## ENERGY & ENVIRONMENT

Re: Arkansas Division of Environmental Quality Comments on the Proposed Ozone Transport FIP  
**Docket ID No. EPA-HQ-OAR-2021-0668**

Appendix A: DEQ Comments on EPA’s Proposed 2015 Ozone Transport SIP Disapproval ..... 21

Figure 1: Historical NOx Emission Data for Honeywell International

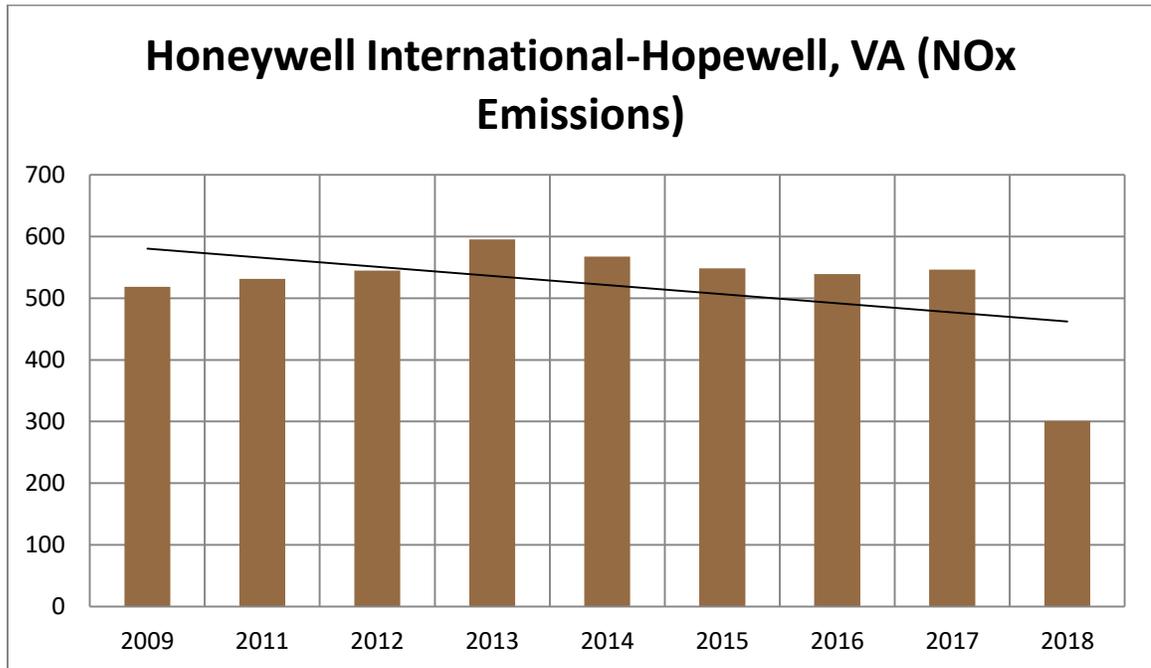
4. The future year projection factor for NOx emissions from "Honeywell International Inc. – Hopewell" (unit# 20375813) in Virginia is 6.79 for 2026 in the 2016v2 platform and was 0.63 for 2028 in 2016v1 platform. DEQ conducted trend analyses to evaluate some future year projection factors and DEQ's analysis for this source does not appear to support a future year projection factor of 6.79 and may support a future year projection factor of 0.62; however, Virginia may have suggested the 6.79 as the appropriate value and, if so, would likely be the best source of this data. DEQ suggests that EPA verify the above example, possibly with Virginia if data was not already provided by Virginia, and other similar examples.

Figure 2: Historical Emissions from John W. Turk Power Plant, AR

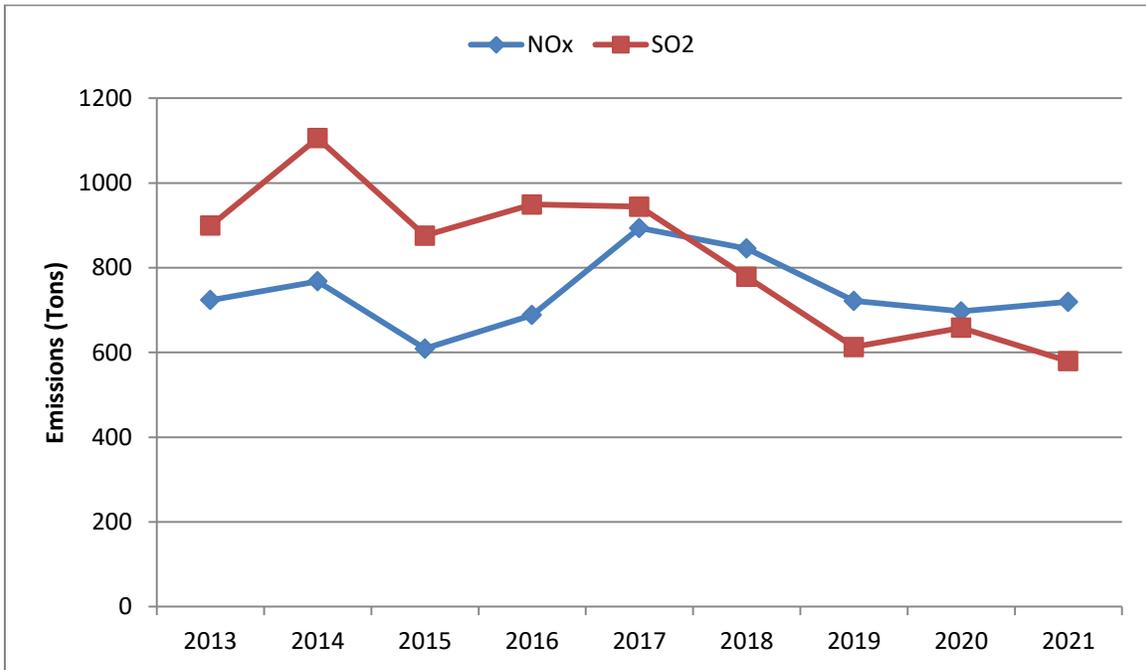
8. IPM did not project 2026 and 2032 ptegu sector emissions for the John W. Turk Power Plant. However, IPM did project 2026 and 2032 ptnonipm sector emissions for this facility of NOx at less than 1 ton and SO<sub>2</sub> at less than 1 ton. Historical NOx and SO<sub>2</sub> emissions for the John W. Turk Power Plant are presented in Figure 2. EPA should include appropriate 2026 and 2032 ptegu sector emissions and verify the 2026 and 2032 ptnonipm sector emissions for the John W. Turk Power Plant.

Figure 3: Historical Emissions from Plum Point Energy Station, AR

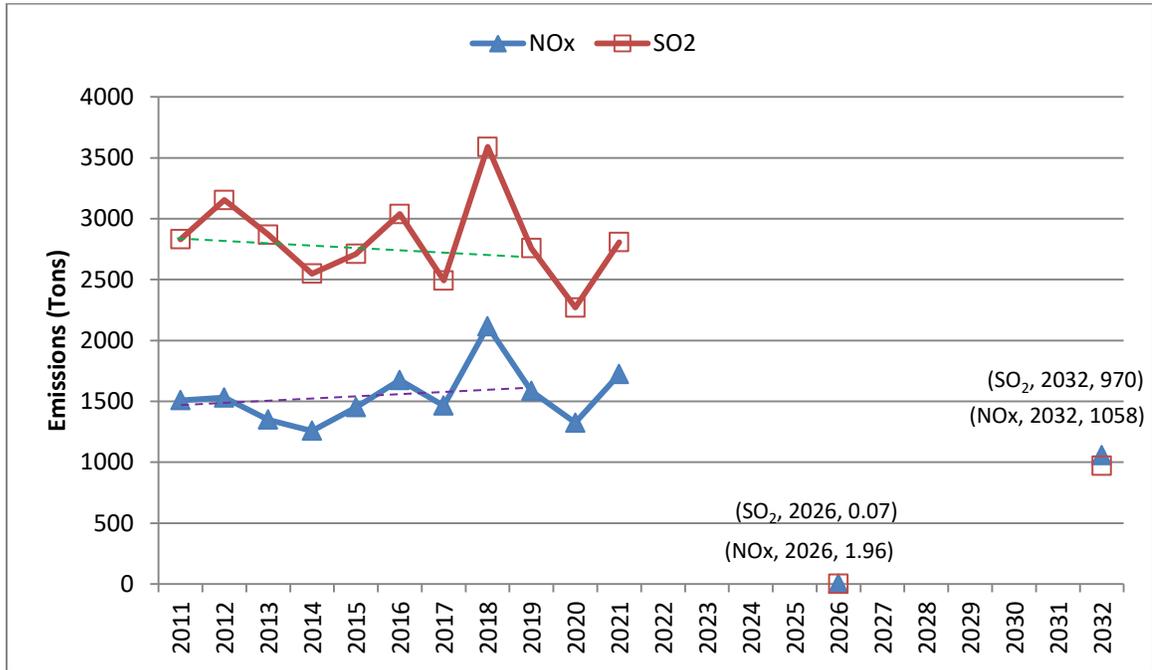
9. IPM did not project 2026 ptegu sector emissions for the Plum Point Energy Station. However, IPM did project 2026 ptnonipm sector for this facility of NO<sub>x</sub> at 1.96 tons and SO<sub>2</sub> at 0.07 ton. Historical emissions for the Plum Point Energy Station are presented in Figure 3. In addition, IPM did project 2032 ptegu emissions, although the 2032 ptegu future year projection was a 62% reduction for SO<sub>2</sub> emissions from a 2021 baseline. For the Plum Point Energy Station, EPA should include appropriate 2026 ptegu sector emissions, verify the 2026 ptnonipm sector emissions, and verify the reasonableness of the 2032 ptegu SO<sub>2</sub> emissions.

Figure 4: Historical Emissions from Oswald Generating Station

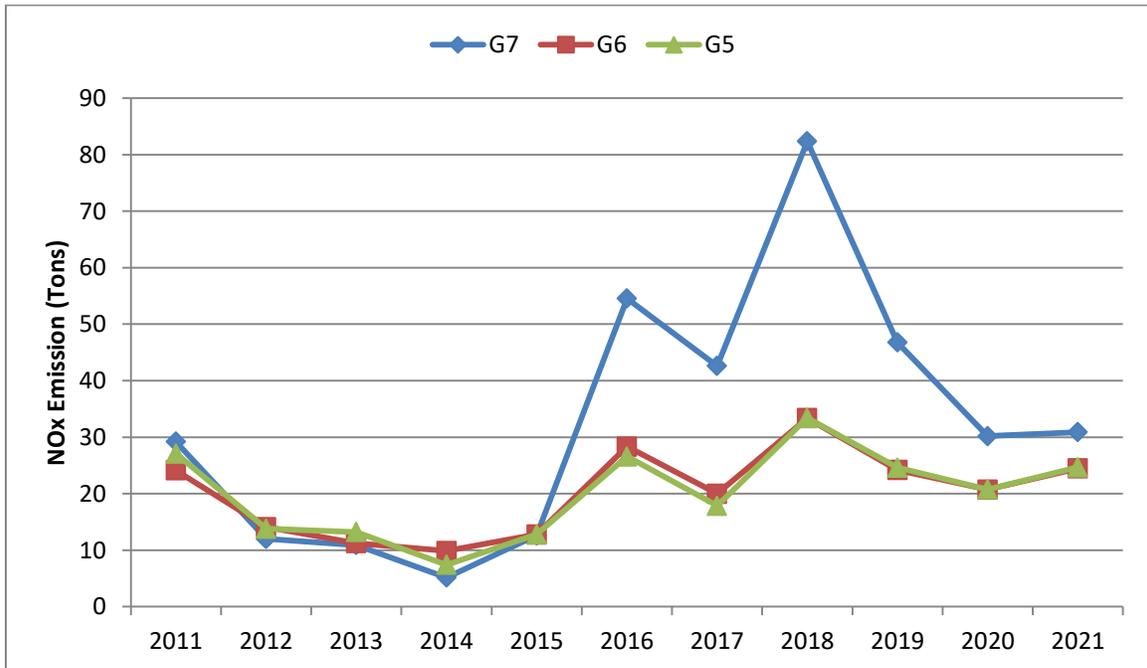
10. IPM 2026 projected NOx emissions from the ARK Elec Co-Op-Oswald Generating Station are Unit G7: 172 tons, Unit G6: 115 tons, and Unit G5: 115 tons. IPM 2032 projected NOx emissions are Unit G7: 160 tons, Unit G6: 107 tons, and Unit G5: 107 tons. Table 1 provides gross load from IPM future year projections and a 5-year average of historical data (2017-2021) for these units. The 2011-2021 historical NOx emissions for these units are provided in Figure 4. EPA should verify the reasonableness of projected 2026 and 2032 NOx emissions for all of this facility’s units and potentially for IPM-projected emissions at other facilities.

Figure 5: Modeled Contributions from All Linked States to Harris County, TX monitor (482010055)

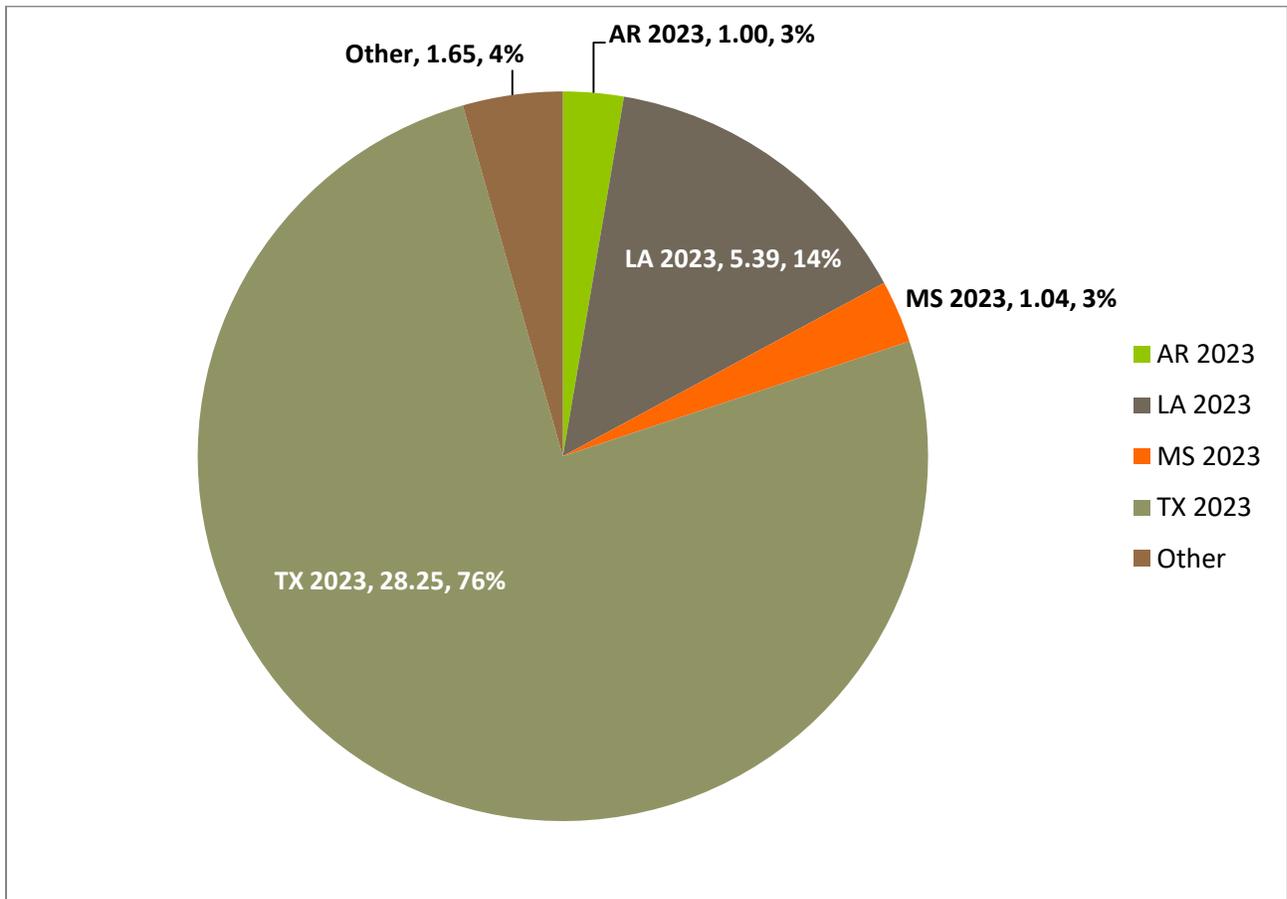
As a snapshot illustration of this point, Arkansas's linked contribution to the Harris County nonattainment monitor is modeled at 1.00 ppb. The modeled contribution from Texas is 28.25 ppb, more than 28 times the contribution from Arkansas, and Louisiana's contribution is 5.39 ppb, more than 5 times the contribution from Arkansas (see Figure 5). When contributions from international, offshore, initial and boundary conditions, fires, and biogenics are included, Arkansas's contribution falls to 1% of total contributions at the Harris County monitor (see Figure 6). Figures 5 and 6 illustrate the relative contributions from all linked states and the relative contributions from all states as well as international, offshore, initial and boundary conditions, fires, and biogenics.

Figure 6: Modeled Contributions from All Linked States (Including Tribal, International, Offshore, Initial and Boundary Conditions, Fires, and Biogenics) to Harris County, TX Monitor (482010055)

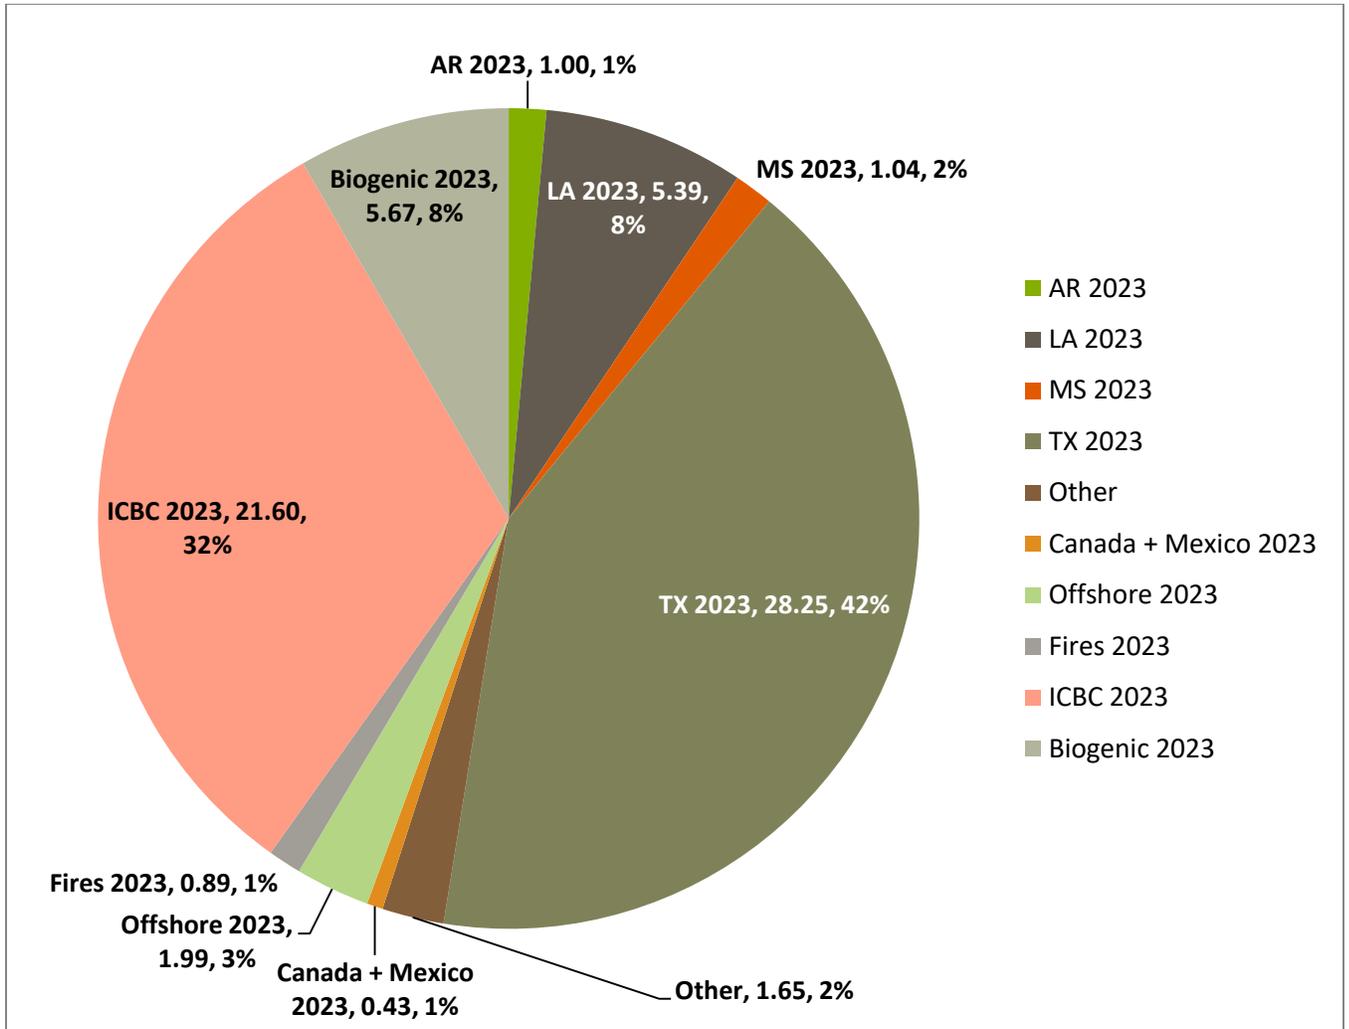
EPA indicates in the Proposed Rule and their proposed FIP that any identified “linkage” to a downwind receptor at 1% or greater automatically means that every source or emissions activity in the upwind state has a “significant contribution,” and is thus ripe for control. In their proposed FIP, EPA did not identify specific sources or emissions activities in Arkansas that significantly contribute to downwind air quality problems (as the rule requires), but instead chose from a nationwide set of sources with available control technologies as being subject to emission reduction requirements in their proposed FIP. There was no further analysis provided by EPA to show that specific sources in Arkansas are actually contributing significantly to the Harris County monitor or interfering with maintenance of the NAAQS by other receptors, thus EPA is
